1996 Maxi-Lift

**MAXI-LIFT INC. SPECIFICATION SUMMARY  
INDEX**

MAXI-LIFT, INC. PROPOSED WAREHOUSE AND MANUFACTURING FACILITY  
MIDWAY ROAD, ADDISON, TEXAS

SUBJECT: FIRE CODES ON SMOKE VENTS AND DRAFT CURTAINS OF CITIES  
SURROUNDING THE CITY OF ADDISON.

1 Section at 72" RCP HEADWALL  
Facing South

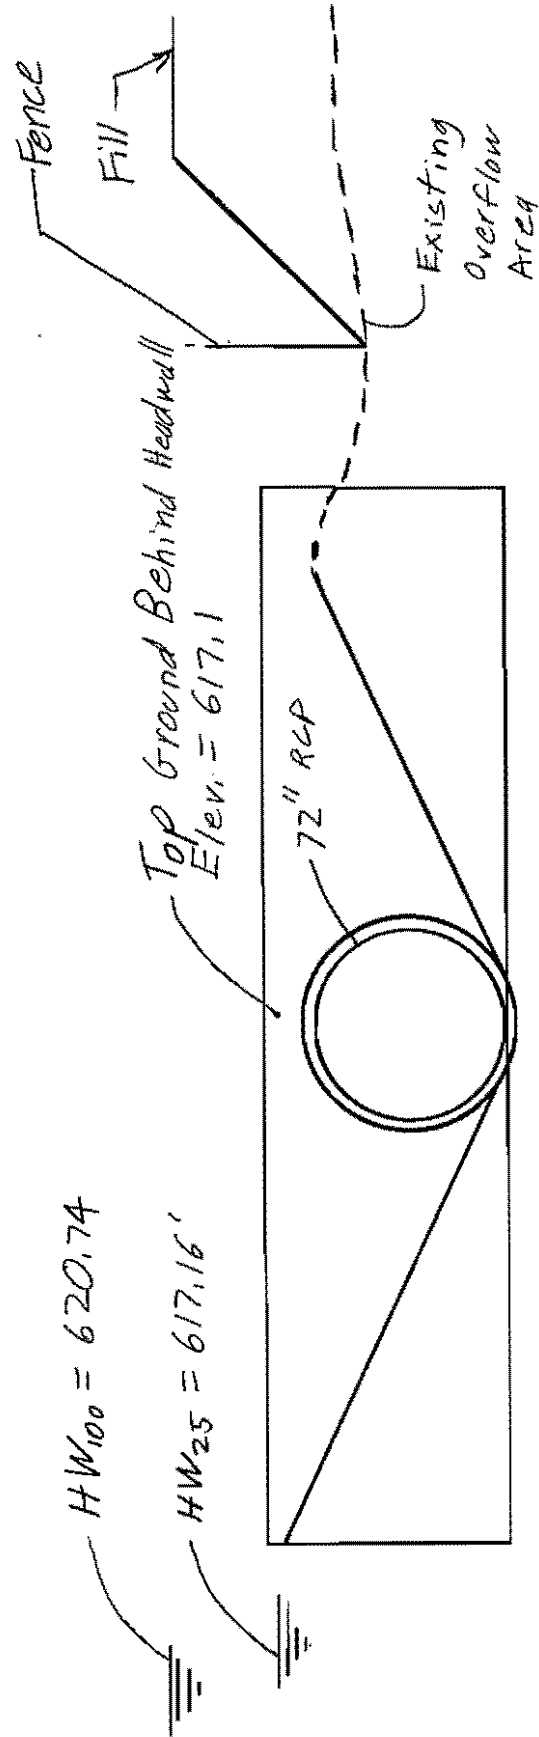
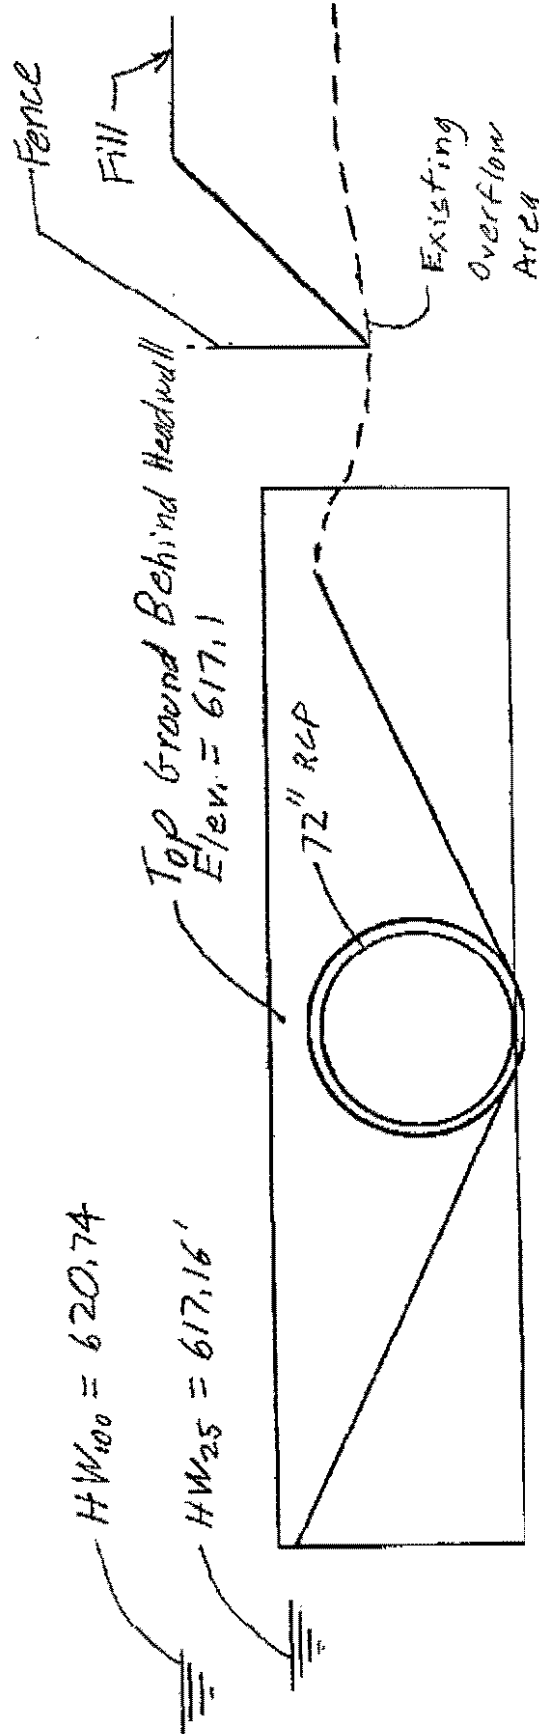
The water causing the damage is flowing around the 72" RCP running north of the double 7'x6' RCB along the west property line of the airport.

This system was designed for a 25 year rainfall event. According to the Design Engineer's Report for the Runway and Taxiway Drainage Improvements, the headwater elevation at the upstream end of the pipe is 617.16 feet if the 25 year peak flow is confined to the pipe. The ground elevation directly over the pipe is approximately the same as the 25 year headwater. The existing elevation of the ground at the fence line and on the adjacent property when the pipe was installed was a few feet lower allowing water to flow overland west of the pipe in the existing overflow area during high flow periods. This did not create a major problem because the water had a large area to flow through and therefore flowed at low velocity. The larger flows for the 50 and 100 year events were similarly spread over a large area with little damage.

When the land within this overflow area was filled, the area available for flow was reduced resulting in higher headwaters and velocities. In addition, the toe of the fill slope is very close to the fence. This directs the flow along the fence line where erosion damage is least tolerable. Also, when the riprap was placed on the north bank of the open channel by the developer, no provision was made to accommodate the flow from the existing overflow area west of the pipe. As a result, the water from the overflow area gathered behind the riprap and pushed it over.

The problem may be solved by removing the fill in the area adjacent to the fence to allow the water to flow as it did previously with an outfall built to direct the water into the open channel. Another alternative is to add another pipe from the headwall to the open channel. In either case the outfall at the open channel should be designed to direct the flow in the same direction as the

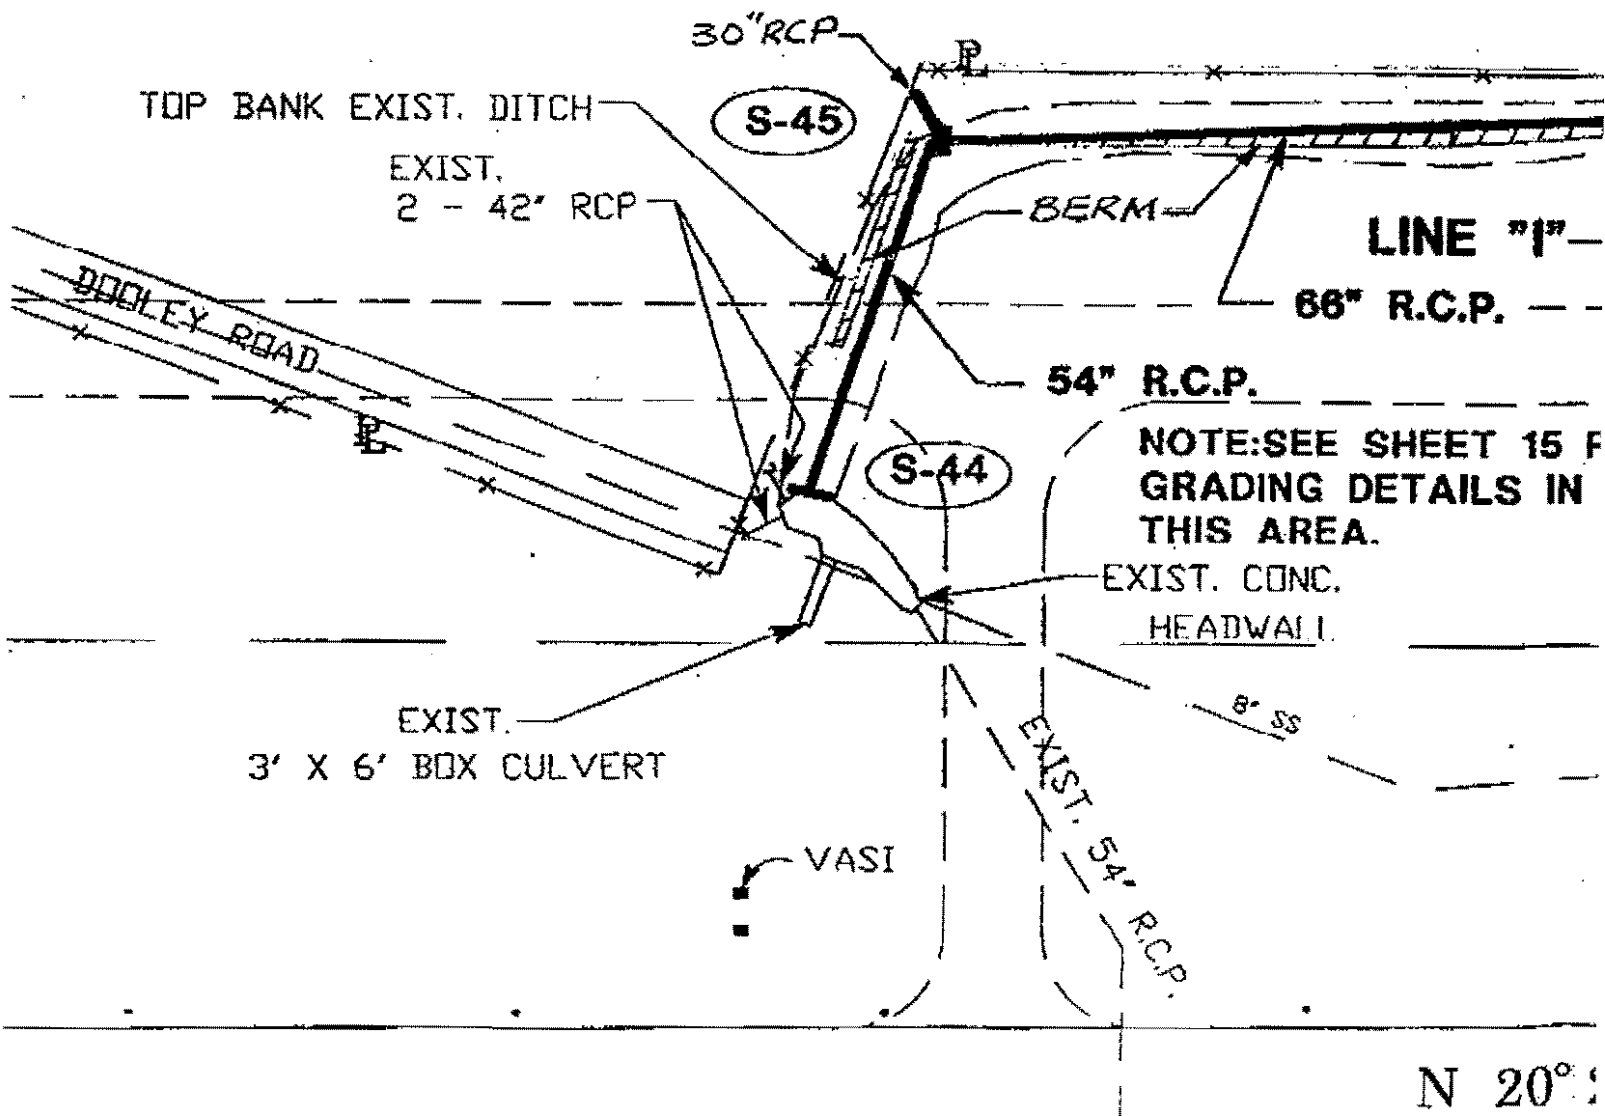
Improve opposite  
Redirect flow in direction  
of flow in channel.

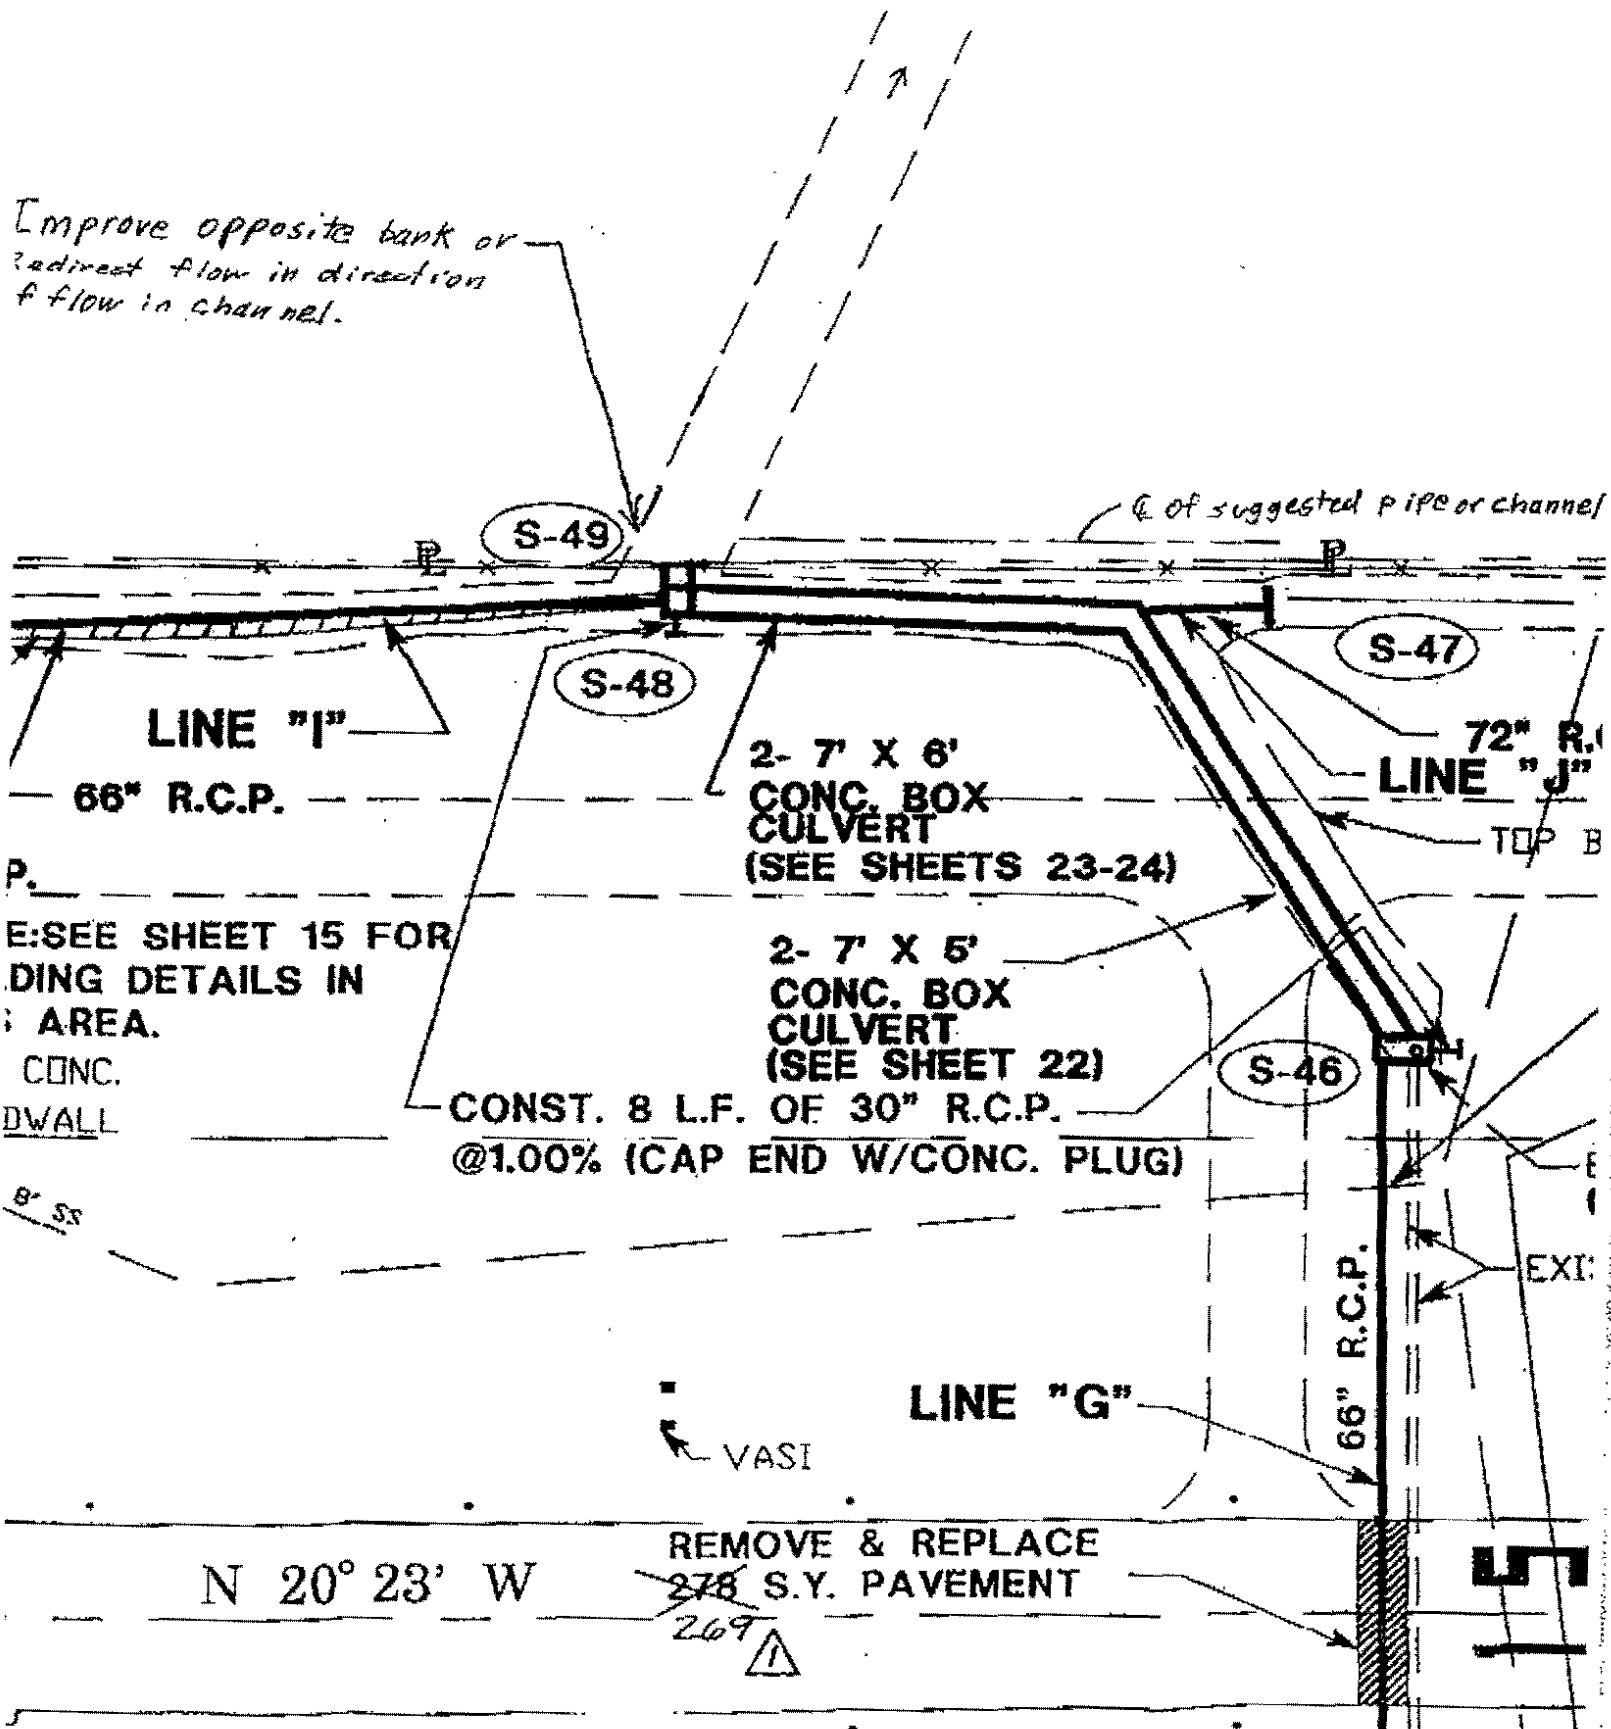
Improve opposite bank or  
redirect flow in direction  
of flow in channel.
